Subject: **Bid No. 8800-M7 – Accessibility Renovations – New Citizen Center / WPS**

ADDENDUM NO. 3

**1407A MAIN STREET
WORCESTER, MA 01603**

ENLARGED FIRST FLOOR PLANS

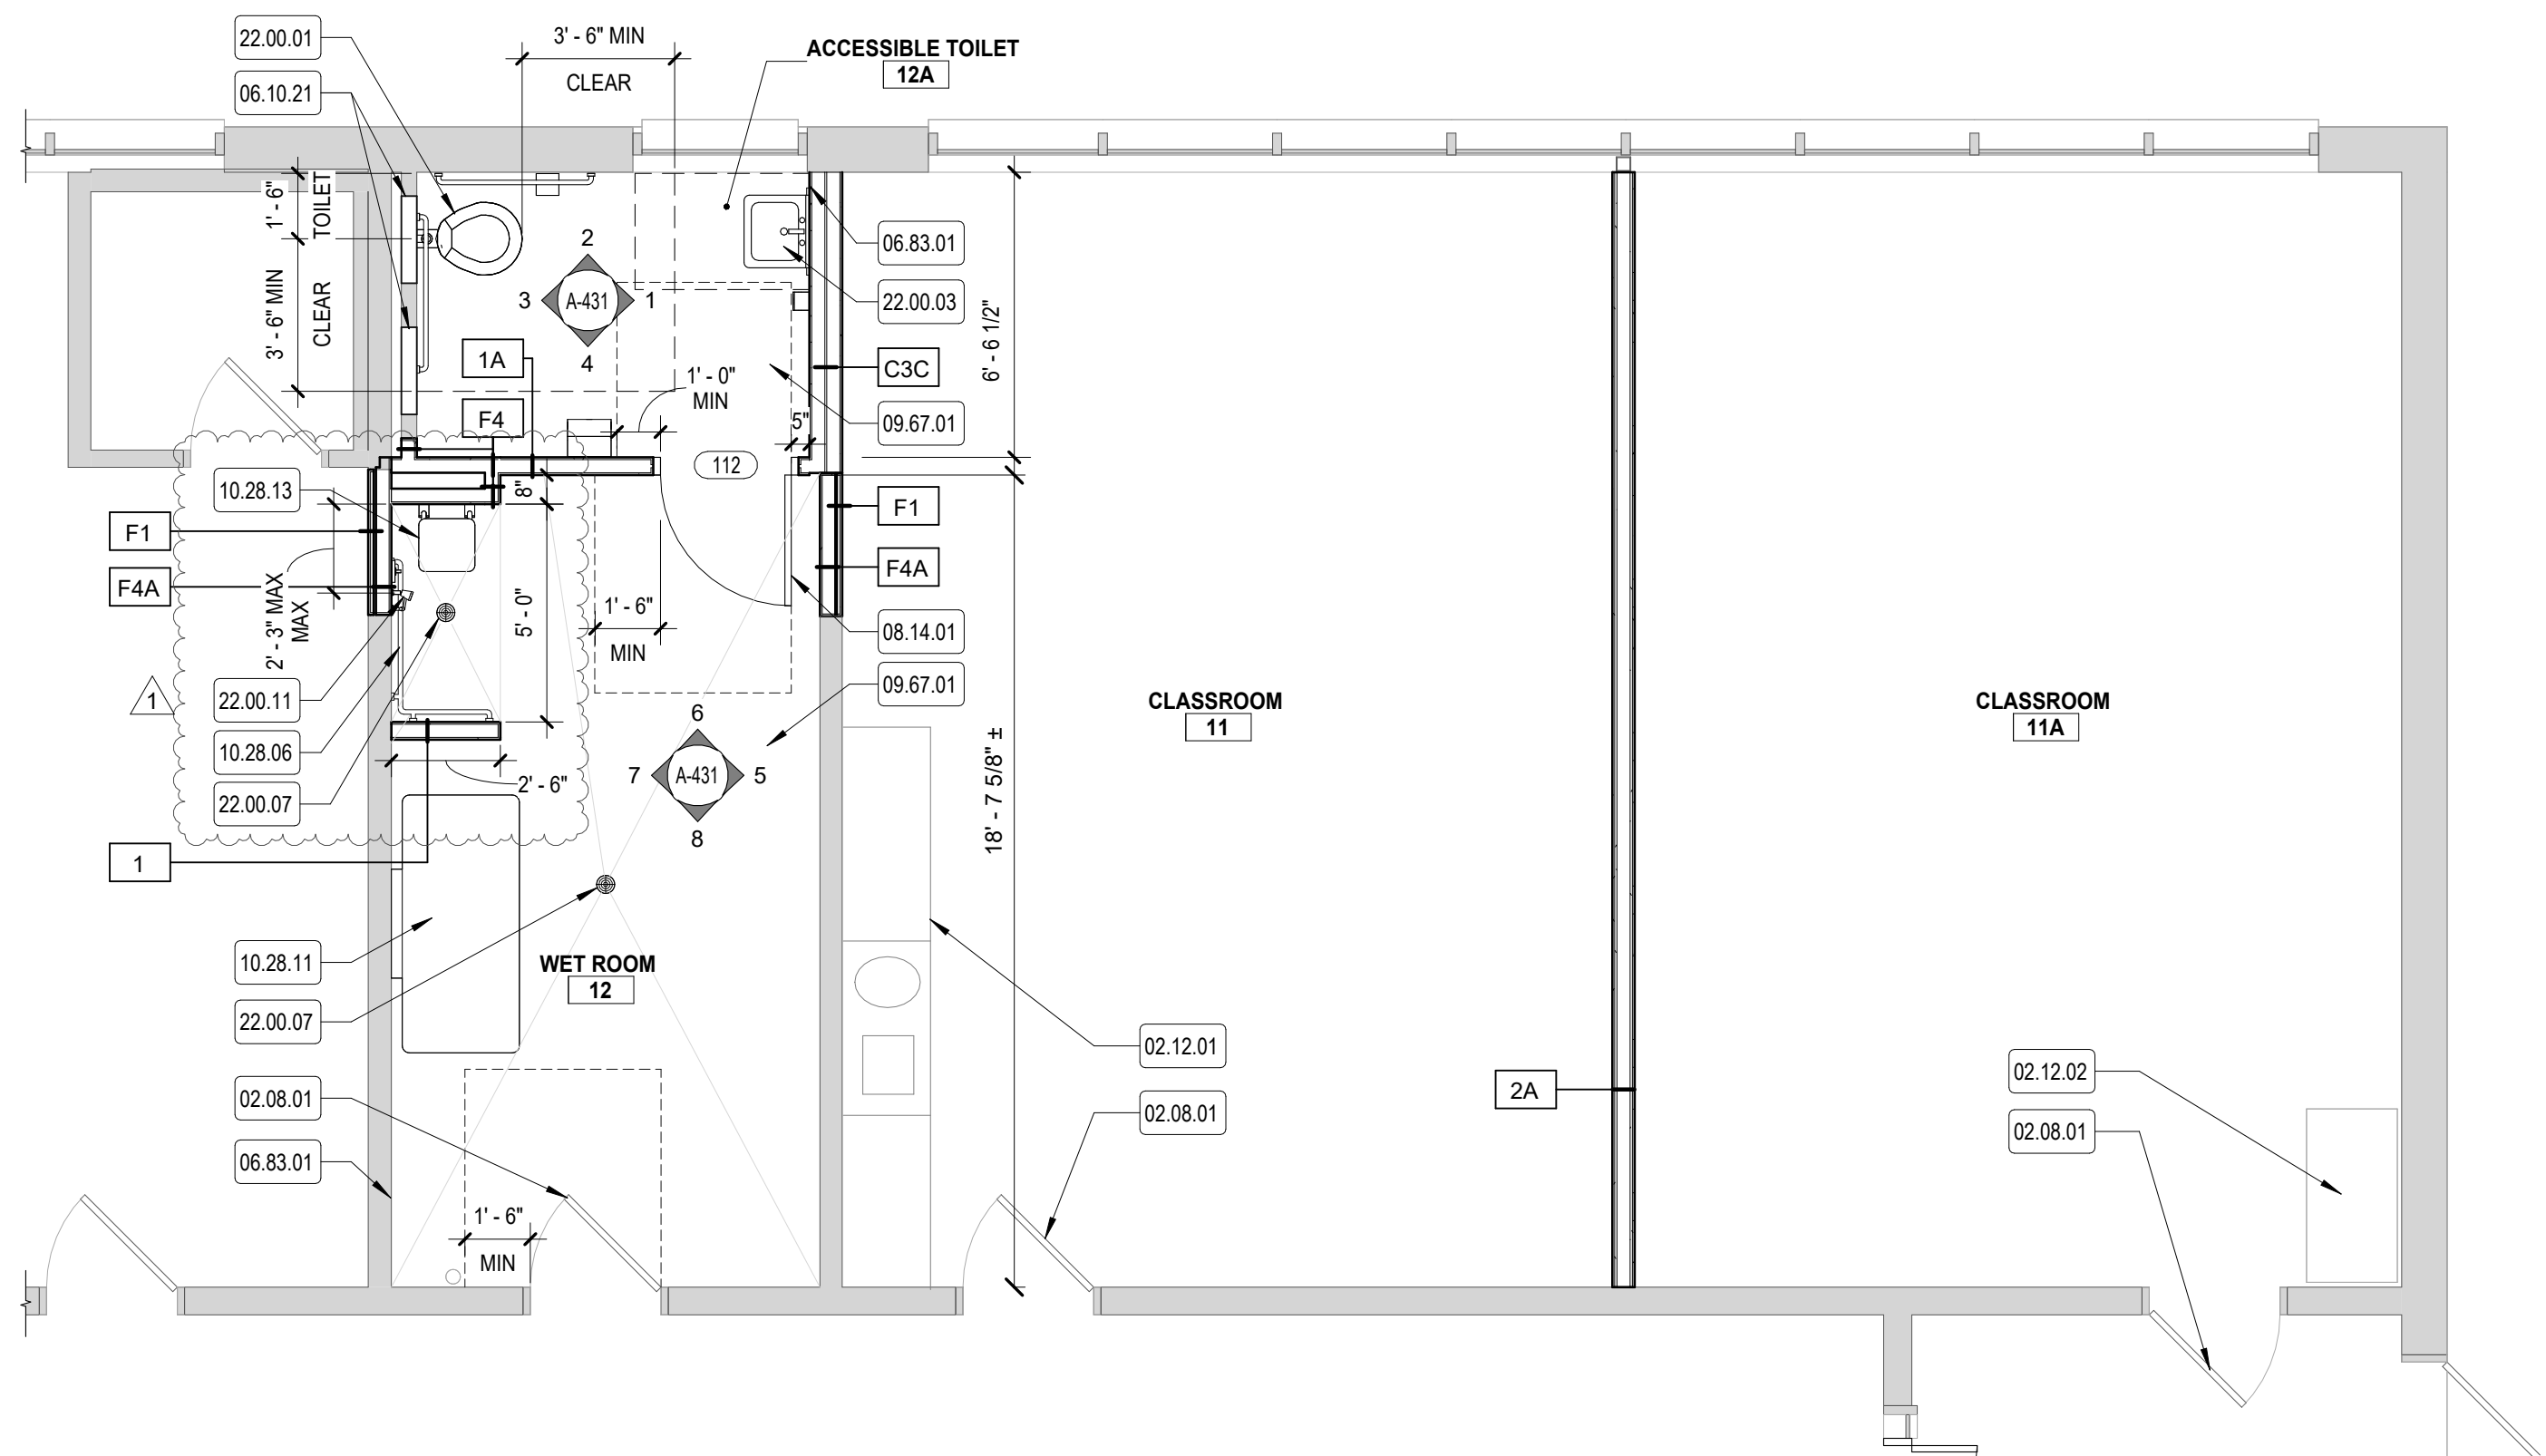
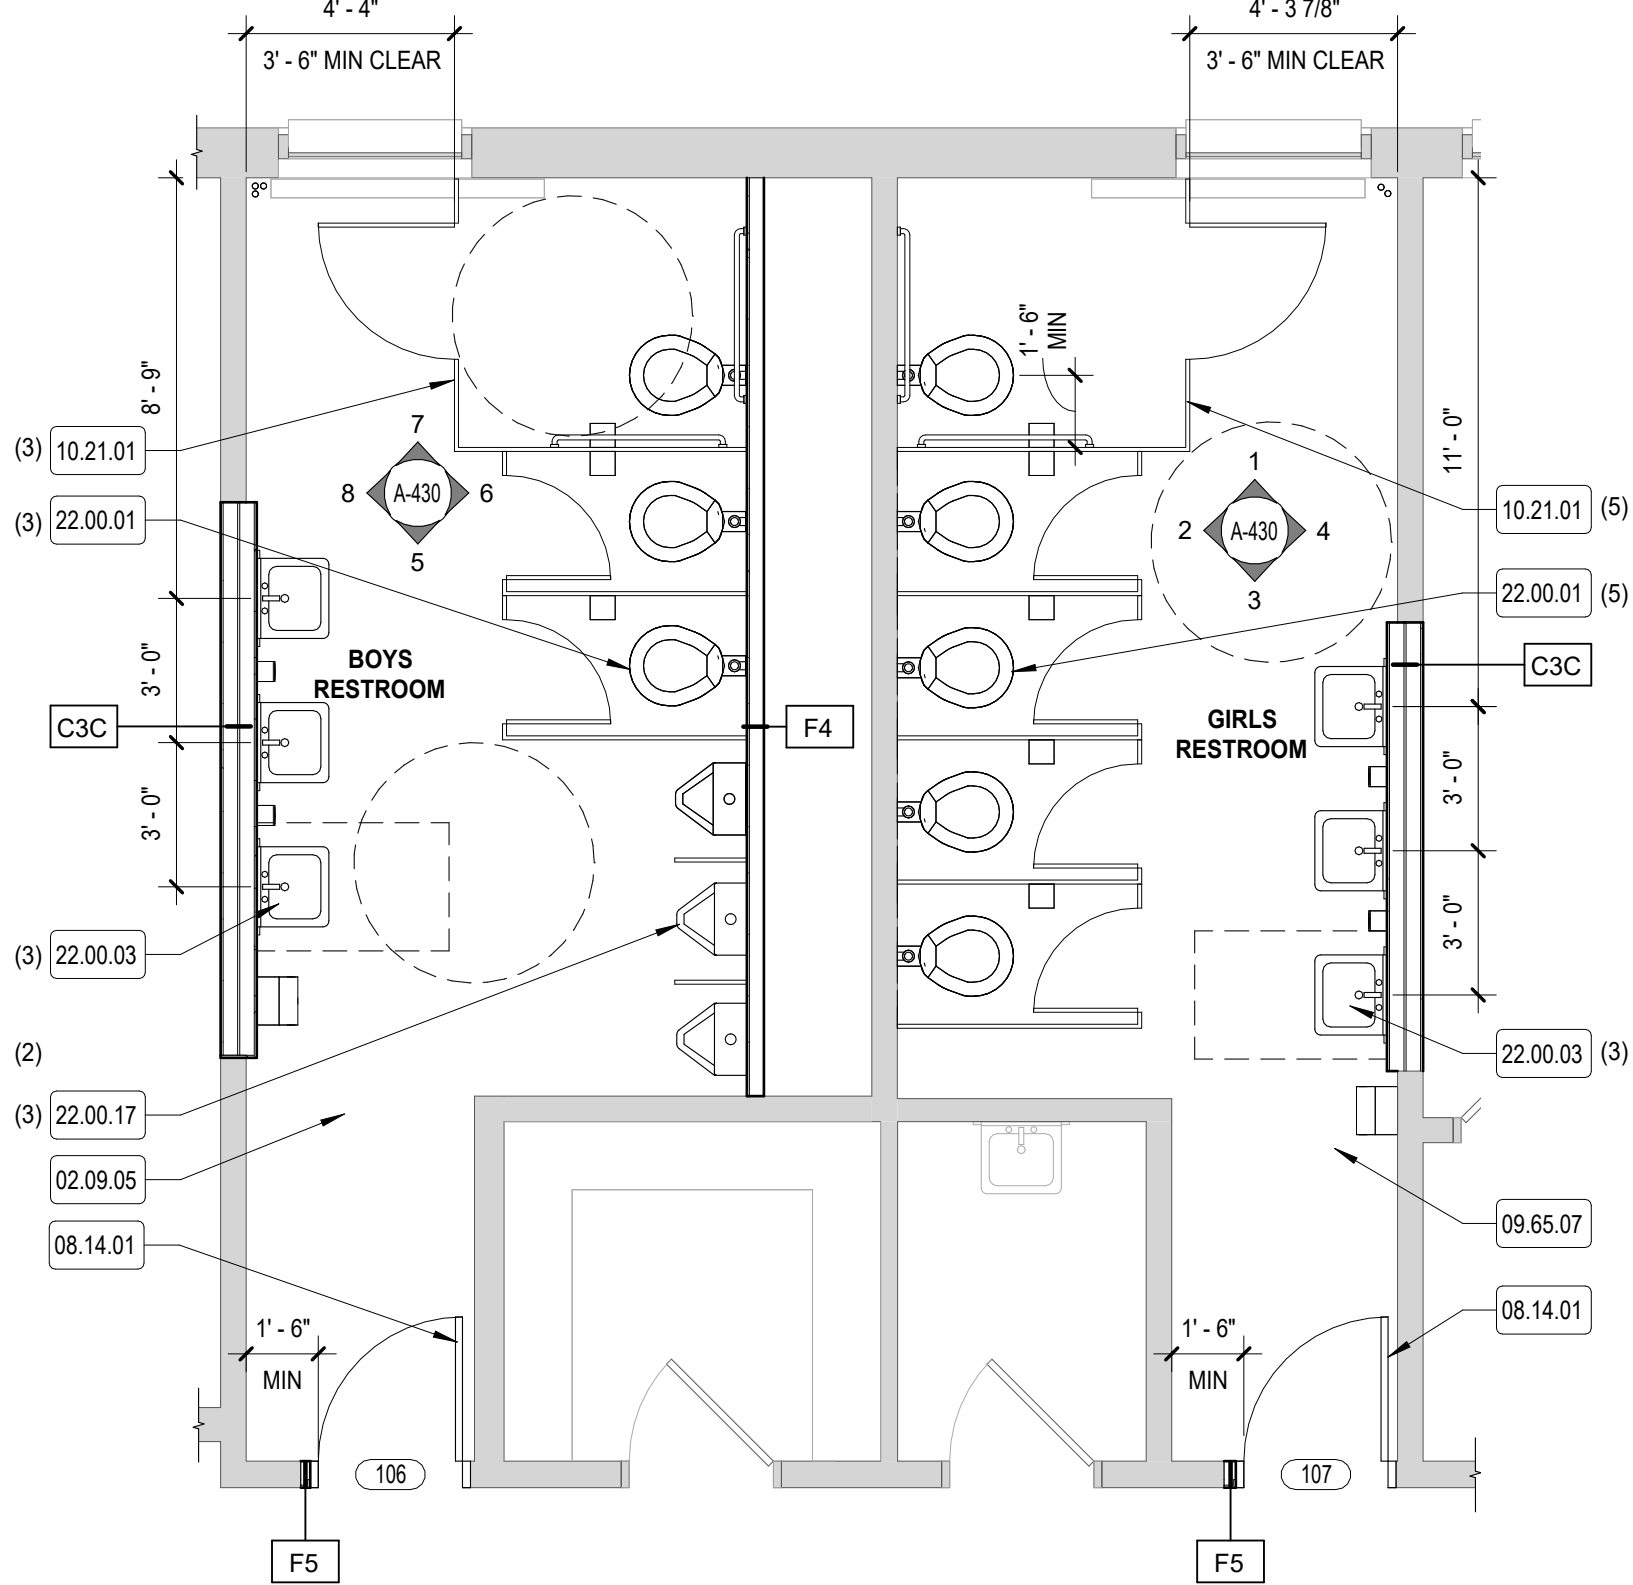
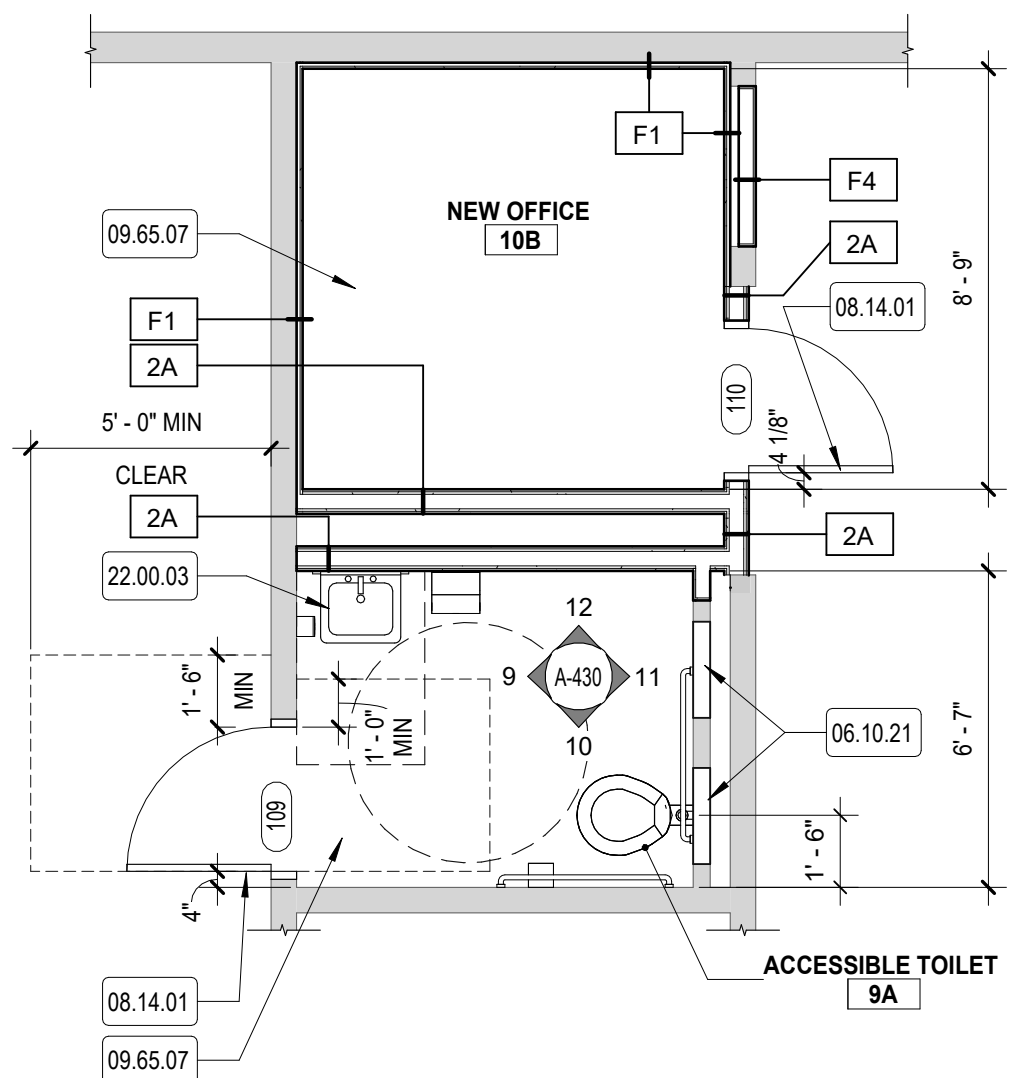
Question:	As we were reviewing the plans we have come across detail 06 10 21 on floor plans but we couldn't identify the details of this component after reviewing the drawings, notes, and the specifications. Could you please clarify the details of it? Please see a screenshot below for the said component for reference. Thank you for your help in advance.

Answer:	Per keynote legend on sheet A-410: "06.10.21 - Wood panel wall infill to match existing". Some wall demolition is expected in order to remove existing fixtures and carriers and should be infilled to match existing once new carriers are installed.
